**STAFF REPORT
FOR THE HISTORIC REVIEW BOARD**

FILE NUMBER: DR-16-05

HEARING DATE: January 24, 2017

REQUEST: Class II Historic Design Review – Modify back porch and create a master bedroom on the main floor. Also, proposing to convert existing attic area to flex space and add dormer to increase head room. A window on the gable will be added on the west elevation and the kitchen window will be replaced with a smaller, counter height window. The applicant is proposing to remove a noncontributing addition to the existing small barn. The front porch will also be rebuilt.

2 PROPOSED EXTERIOR NORTH ELEVATION
SCALE: 1/4" = 1'-0"

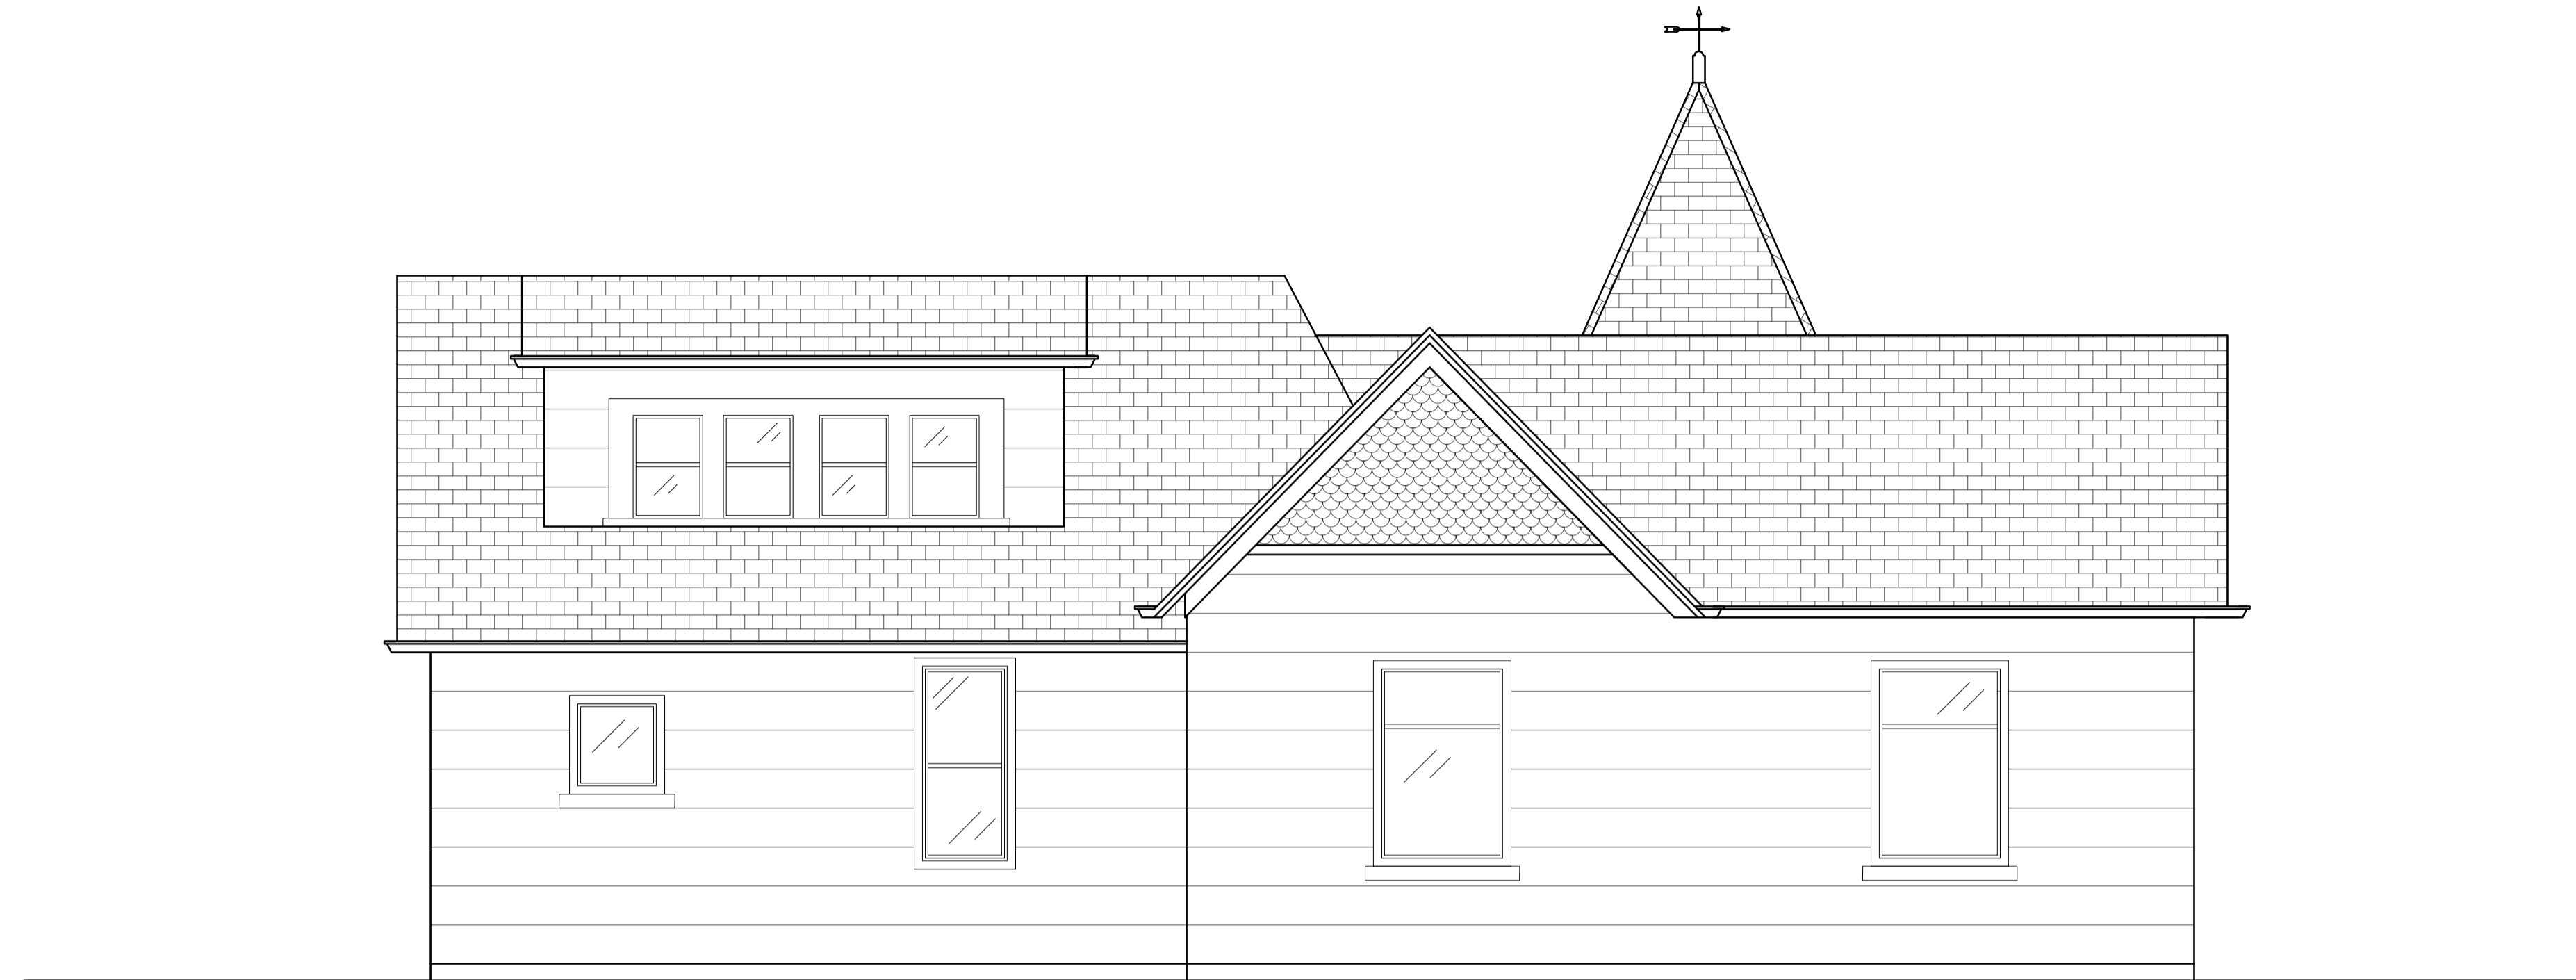
Staff Finding 4: The proposed alteration of the rear elevation is to add a dormer. The materials proposed by the applicant are consistent with the existing materials and architectural details. All other exterior features have and are proposed to be restored. The front elevation will remain the same. The criterion is met.

Staff Finding 8: The proposed dormer to the rear elevation will be compatible to the home's original architecture and will use materials consistent with the existing historic look of the home (see applicant submittal page 5). This criterion is met.

Staff Finding 10: The proposed dormer addition is in the rear of the home and all design features are consistent with the historical character of the existing home. All dimensional standards of the underlying zone are satisfied. This criterion is met.

2 PROPOSED WEST EXTERIOR WALL
SCALE: 1/4" = 1'-0"

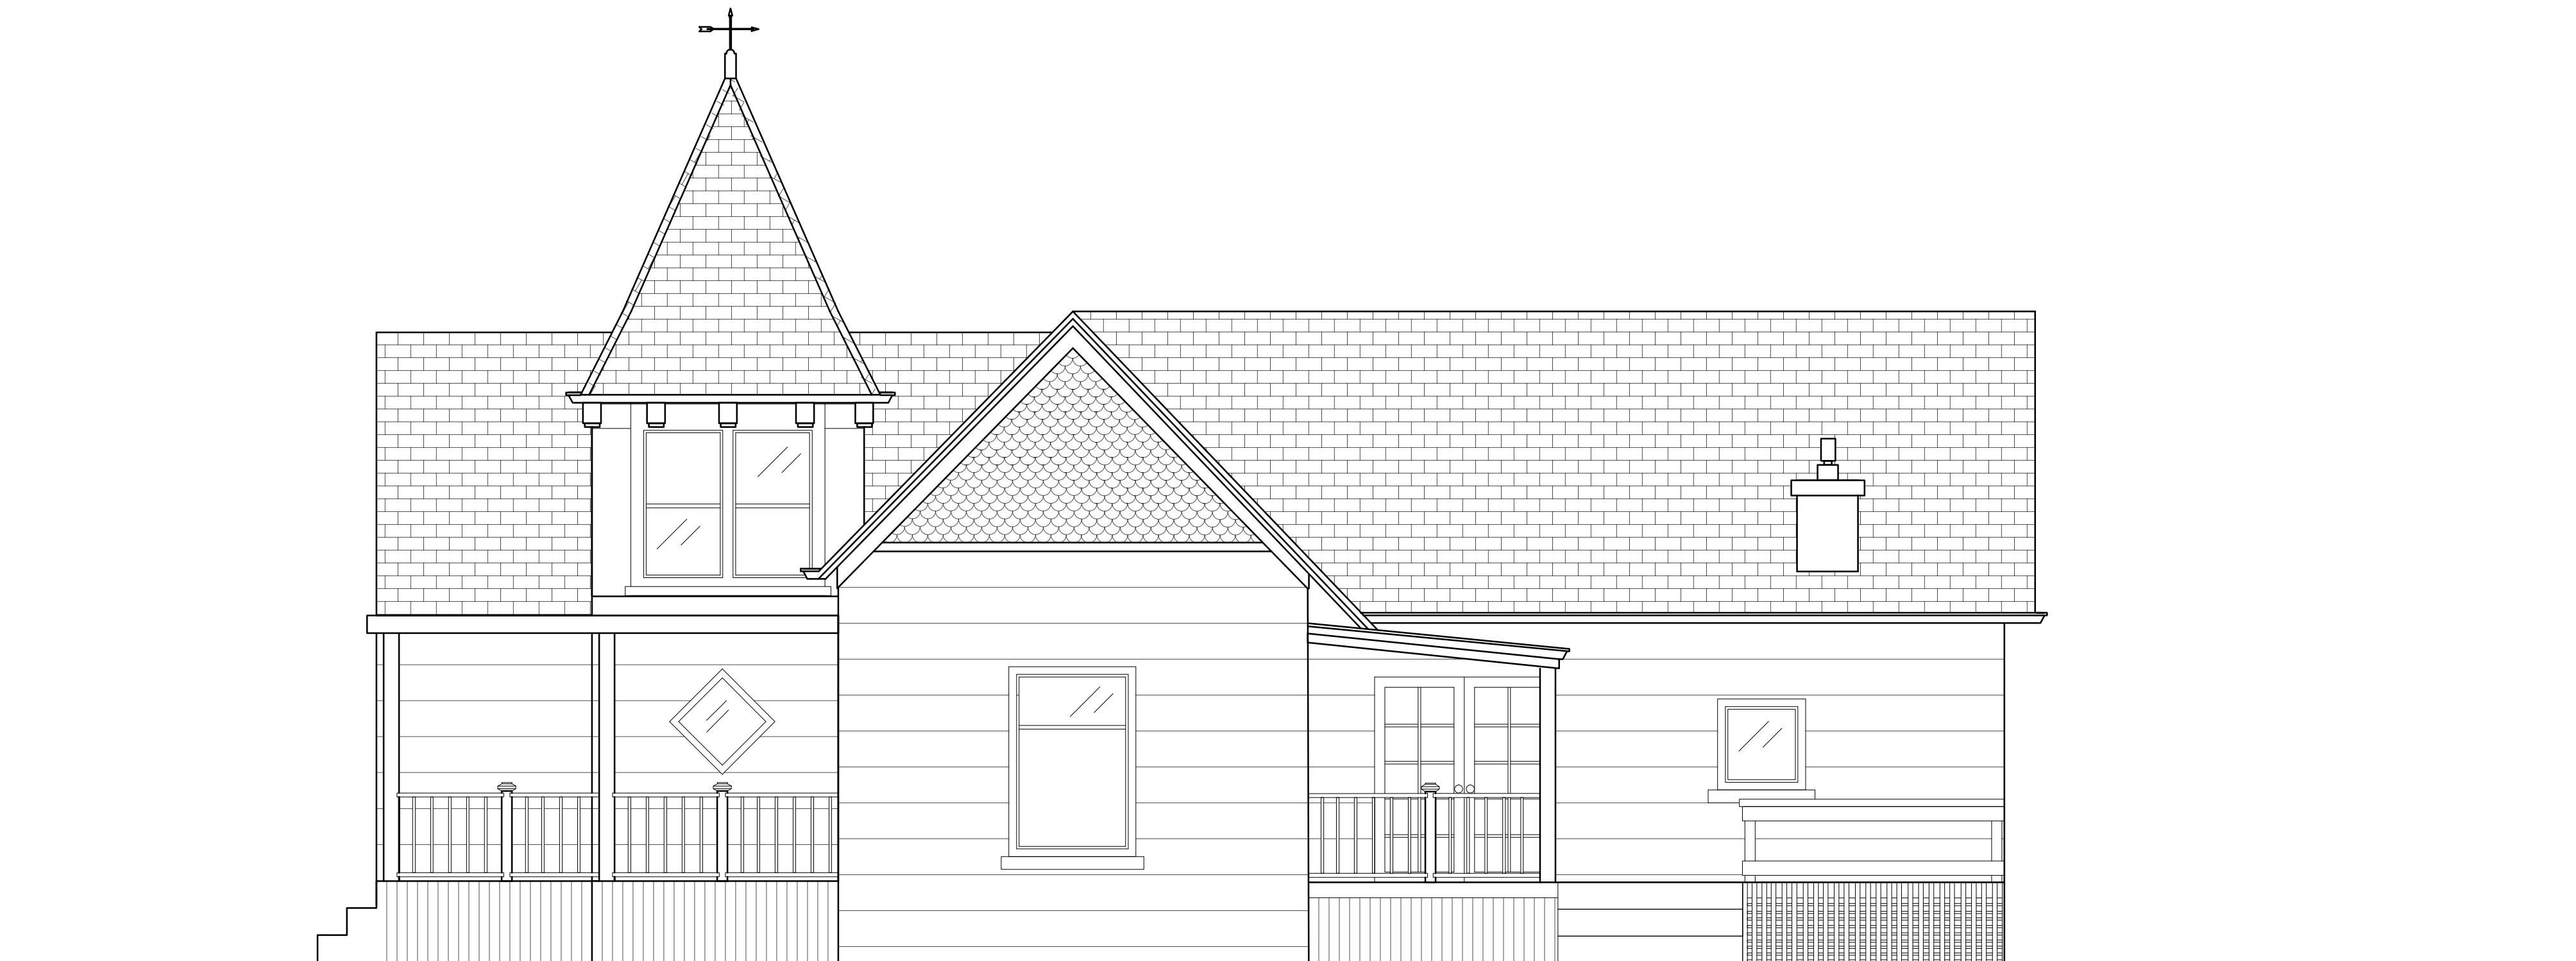
Staff Finding 16: There is one window to be replaced facing 13th street on the west elevation. The replacement window is consistent with the historic character of the home in size, shape, and materials. The window trim will match the proposed historically accurate color pallet. There is one new window proposed in the gable of the west elevation. This will be a diamond shaped window and is consistent with the historical architecture of the home. This criterion is met.
